Subject: Mariposa Energy Project (09-AFC-03)
Robert Sarvey Data Response Set 2, Responses to Robert Sarvey
Data Requests 9 through 37 and 39 through 44, Dated March 15, 2010

ROBERT SARVEY DATA RESPONSES, SET 2
(RESPONSE TO DATA REQUESTS 9 TO 37 AND 39 TO 44, DATED MARCH 15, 2010)

FOR THE
Mariposa Energy Project
(09-AFC-03)

| RSDR15-1 | LM6000 PC Sprint Startup Curve |

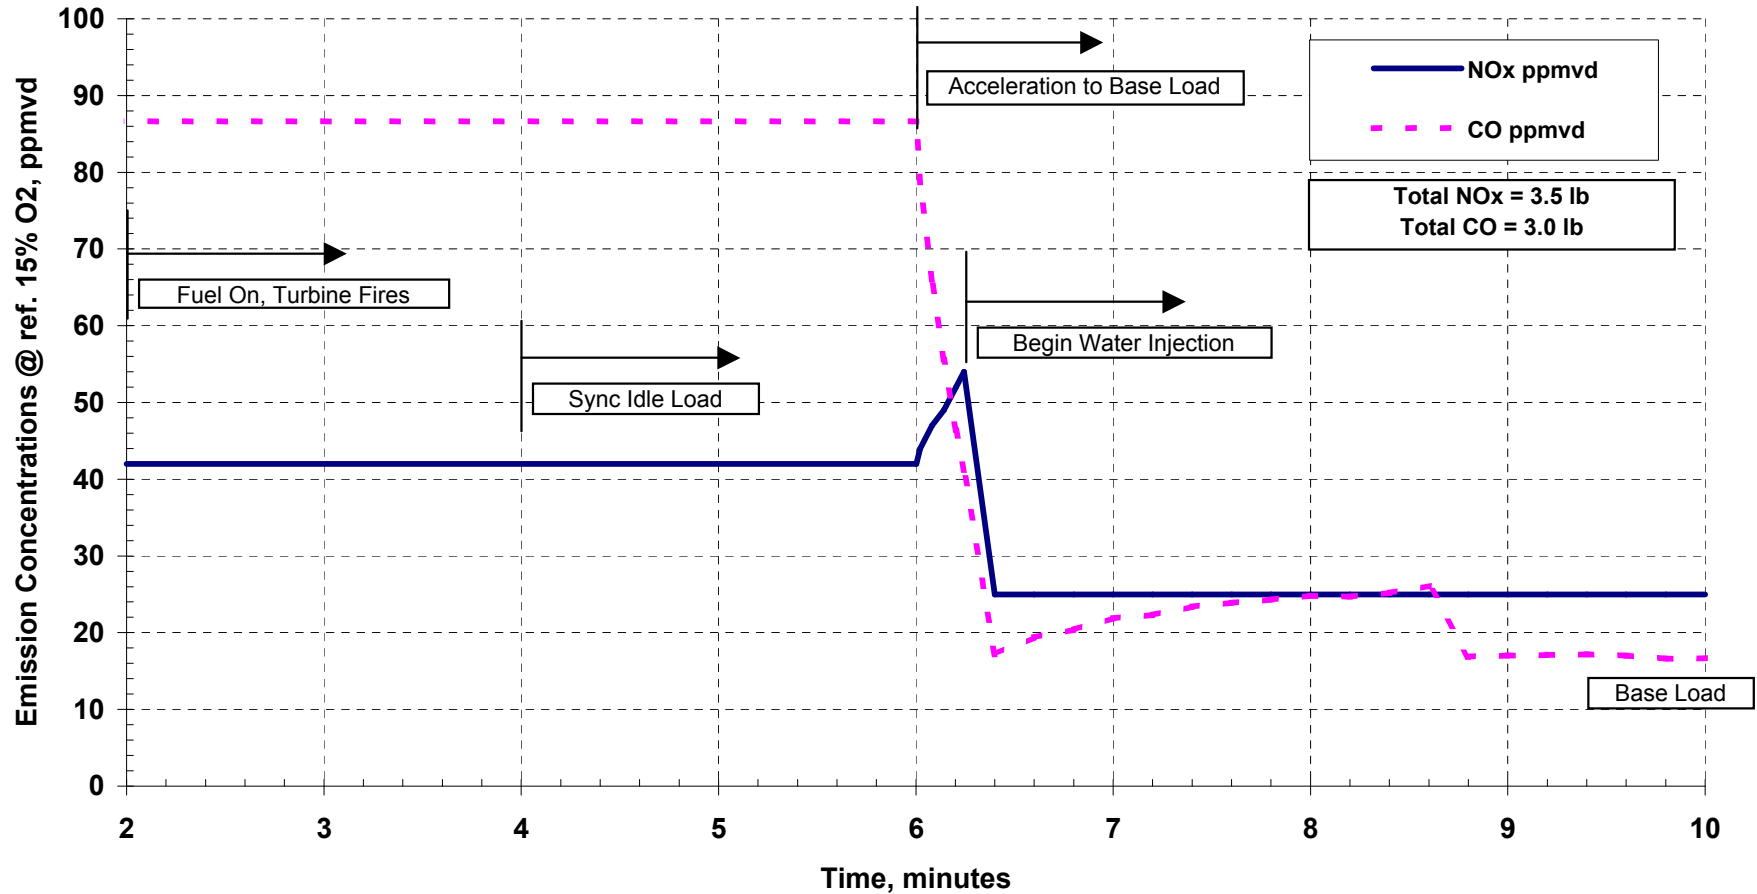
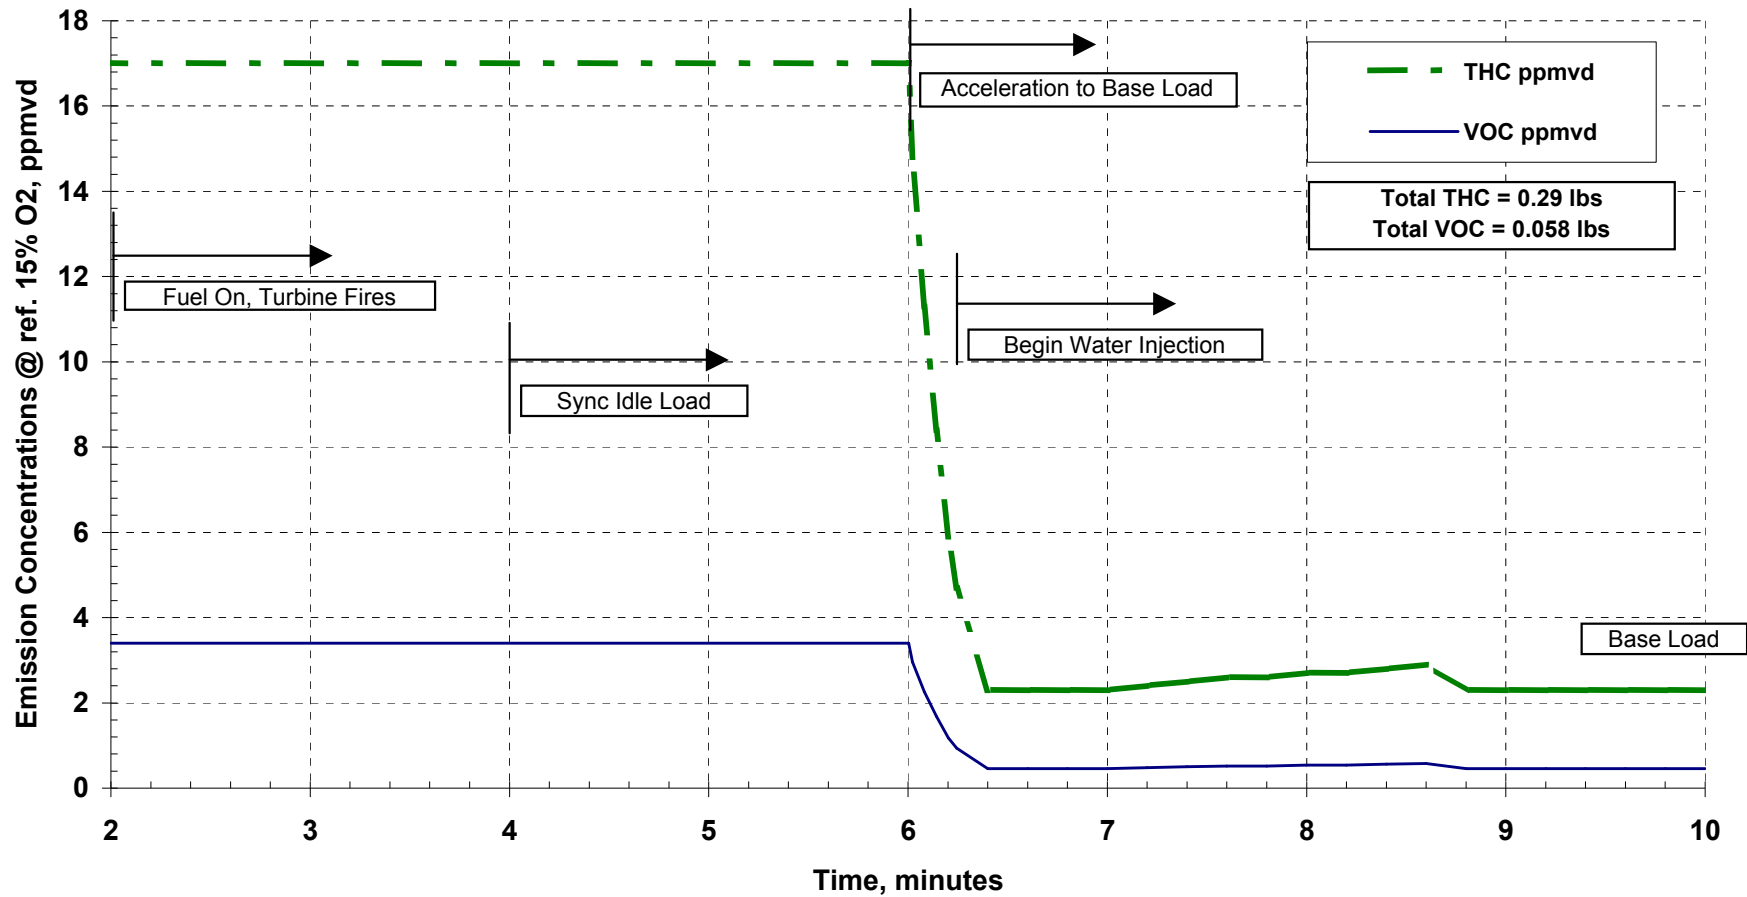
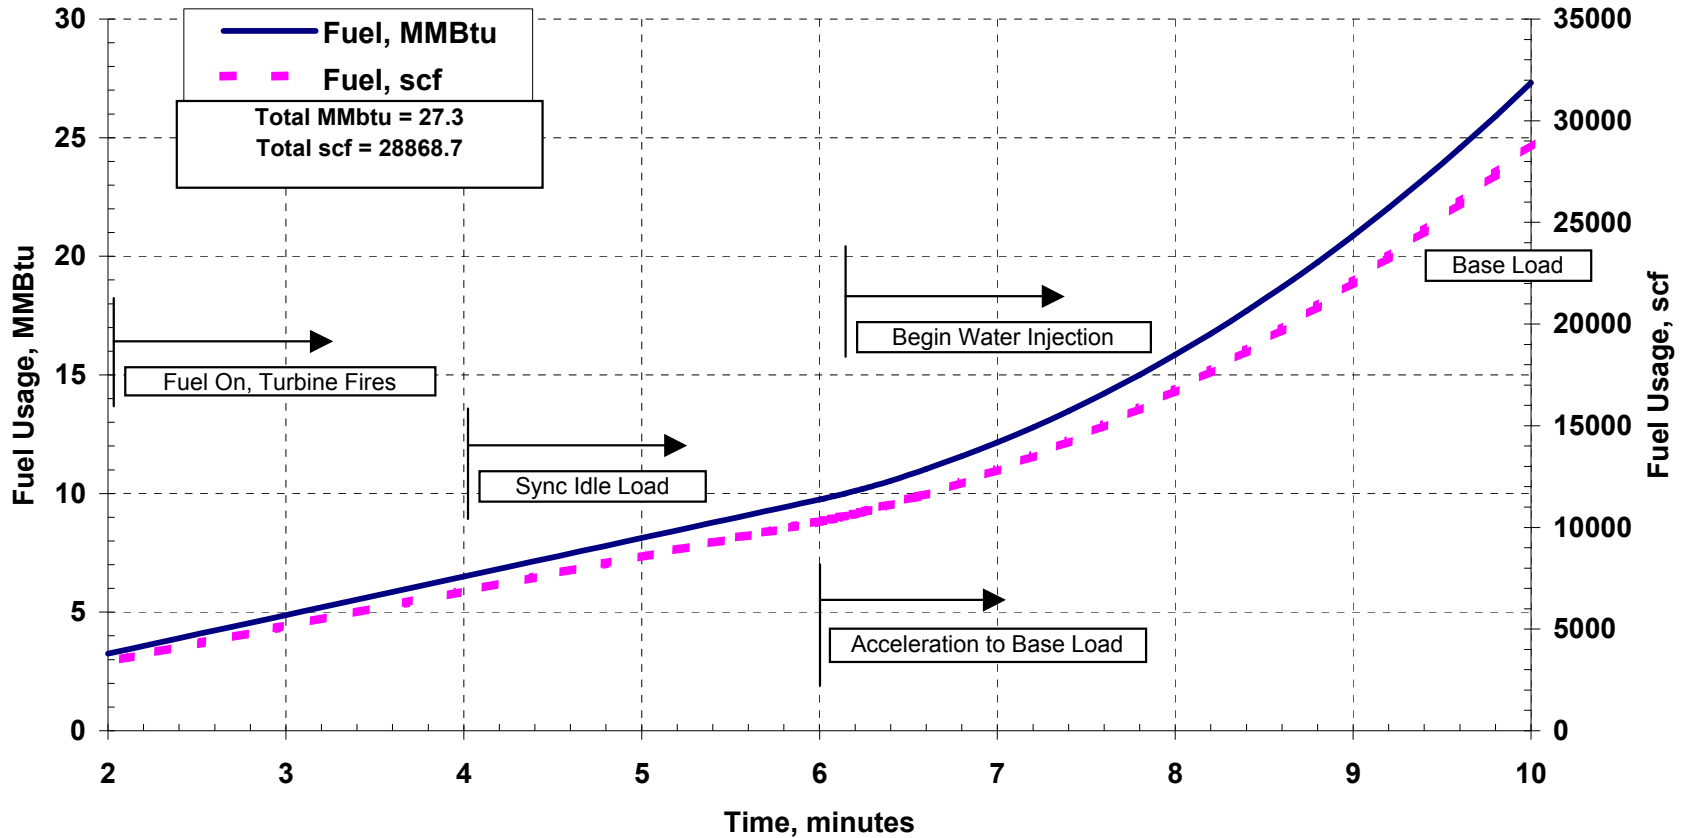
RSDR15. Please provide the projected emission rates for each criteria pollutant in 5 minute increments, from startup to each CTG is stabilized at permitted levels.

Based on the startup emission curve provided by GE, the LM6000 has the ability to reach full power within 10 minutes of initiating a start-up sequence, with first fire occurring at minute 2 of the startup sequence. It is anticipated that additional time will be required for the selective catalytic reduction (SCR) and oxidation catalyst to reach optimum performance temperature and function at permitted levels. Mariposa Energy estimates the SCR control system will be fully functional 14 minutes after the turbine reaches full load, and it is expected the oxidation catalyst efficiency will increase linearly from full load to 20 minutes after full load is achieved. As a result, the startup emission rates for NO_x, CO, and VOC would be approximately 14.2, 14.1, and 1.1 pounds per event (lb/event), respectively. The incremental NO_x, CO, and VOC emission profiles for a startup event are presented in Table RSDR15-1. The GE LM6000 startup curve is included as Attachment RSDR15-1. As the GE LM6000 start up curve includes NO_x, CO, and VOC emission estimates for the 10 minute start up period, Mariposa Energy used these estimated emissions in its assessment.

The PM_{10/2.5} and SO_x emissions rates are correlated to the turbine operating load and associated fuel consumption rate. Therefore, the emission rates for PM_{10/2.5} and SO_x during a startup would not be greater than the maximum emission rate associated with the turbine operating at full load. The PM_{10/2.5} and SO_x emission profiles presented in Table RSDR15-1 are estimated assuming maximum PM_{10/2.5} and SO_x emission rates of 2.5 lb/hour and 0.91 lb/hr, respectively.
